## **CCWEL: SPOKES RESPONSE TO CONSULTATION ON DRAFT TRO DRAWINGS - NOVEMBER 2017**

### **TRO Plan 2**

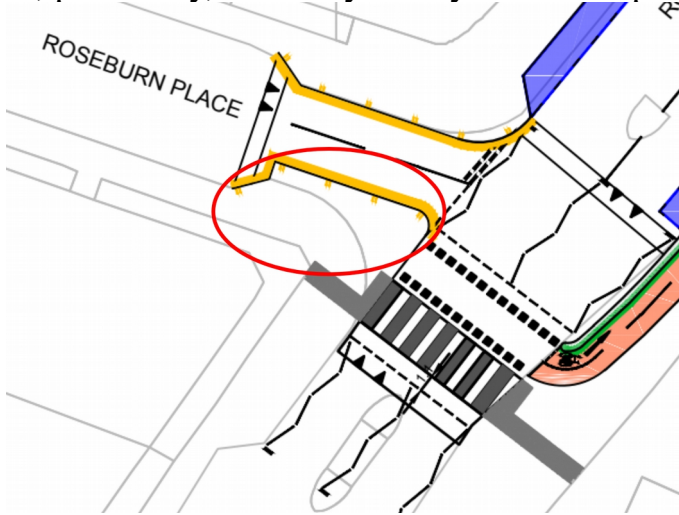
1. The plan shows a small, triangular shaped construction just after the entrance to the park. We are not sure of the purpose of this and consider that it could obstruct cyclists and pedestrians and that therefore it should be removed from the plans.

2. Earlier communication from the Active Travel Team (July 2017) suggested that the access to the park would be 4.5 m. The current plans do not give measurements, but the proposed entrance/exit would seem to be much less than this. Given that a narrow space could create conflict between cyclists and pedestrians we consider that the 4.5m wide access should be retained.
3. Although there is a clear line of sight for cyclists exiting the park, cyclists crossing the road to enter the park can have their sight line obscured by parked cars on the bend at Roseburn Crescent. We consider that the double yellow line should be extended further round the bend in the road to prevent this.

### **TRO Plan 3**

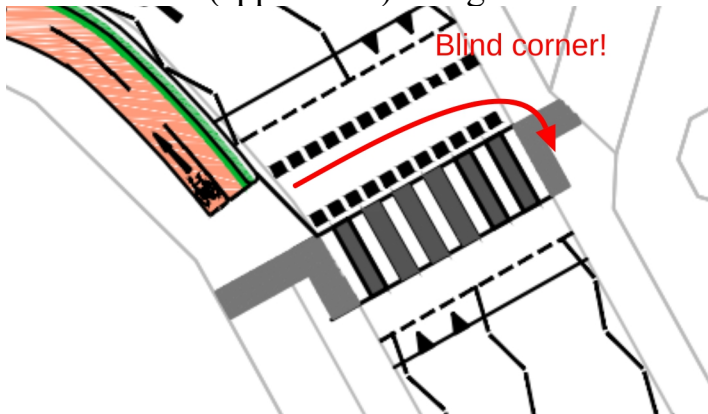
1. It is not clear how cyclists will get to and from Roseburn Place if travelling between Roseburn Place and the new cycleway running along Roseburn Street and into Russell Rd. Although there is a tiger crossing shown across Roseburn Street itself this runs into an area of pavement on the Roseburn Place side. We consider that this area or pavement should be clearly designated for shared use by cyclists and pedestrians or, preferably, a mini cycleway should be provided on the pavement.

2. On Russell Rd, the cycleway ends in a tiger crossing to allow cyclists to cross to the eastern side of the road. However, this is situated directly across from the narrow path from Roseburn Terrace which runs down the side of Tesco's. This results in cyclists turning right with no line of sight to pedestrians coming down the path. To avoid this, we suggest that the cycleway and the crossing should be moved a little further south (approx 1m) along Russell Rd.

3. We have noted that the loading space just beyond Tesco's has been designated for 24 hour use. To help avoid congestion during the peak times (which could unfairly be blamed on the new cycleway), we consider that this loading area should be available only outside of peak hours.

## **TRO Plan 6**

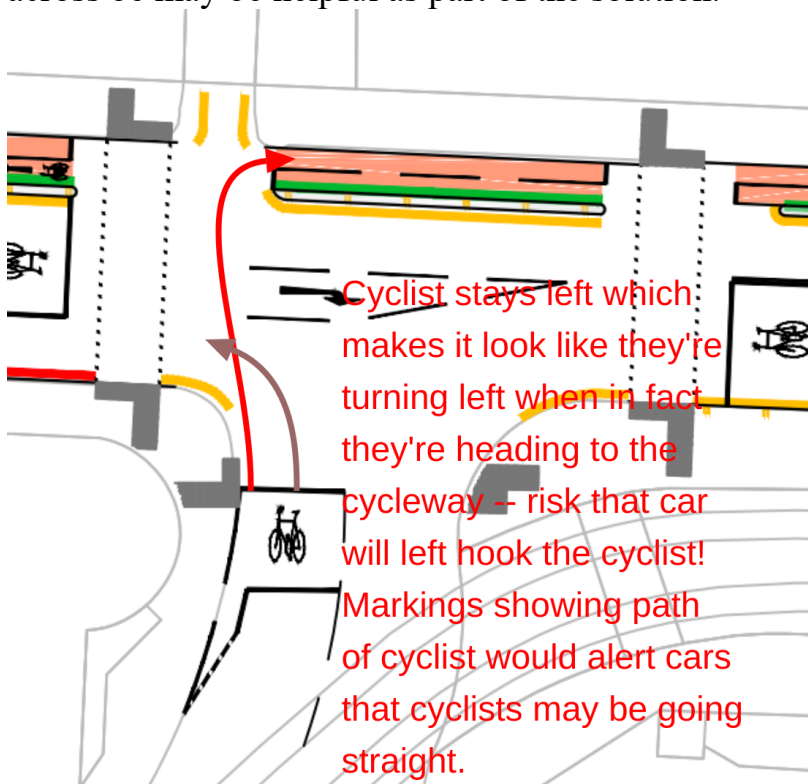
1. We would be grateful for reassurance that the design of what is marked on the map as "developer egress" (and which will become the exit point for cars from the new housing development on the Donaldson site), is now specified adequately to al-

low exiting motor traffic to wait to get a clear view of the road without blocking the cycleway.

2. We are surprised to see that space has been allocated for short term parking (up to 2 hours between 8.30 am and 4.30 pm) from Monday to Saturday at the eastern end of West Coates. This overlaps with the operation of the bus lane and it seems contrary to the advice given to us in July that the stretch of cycleway between Wester Coates Rd to Magdala Crescent could not be widened to 2.5m (the normally minimal acceptable size for a 2 way cycleway) because of “heavy bus/coach flows in both directions”. Given this assessment, how is it possible to now provide additional parking spaces?
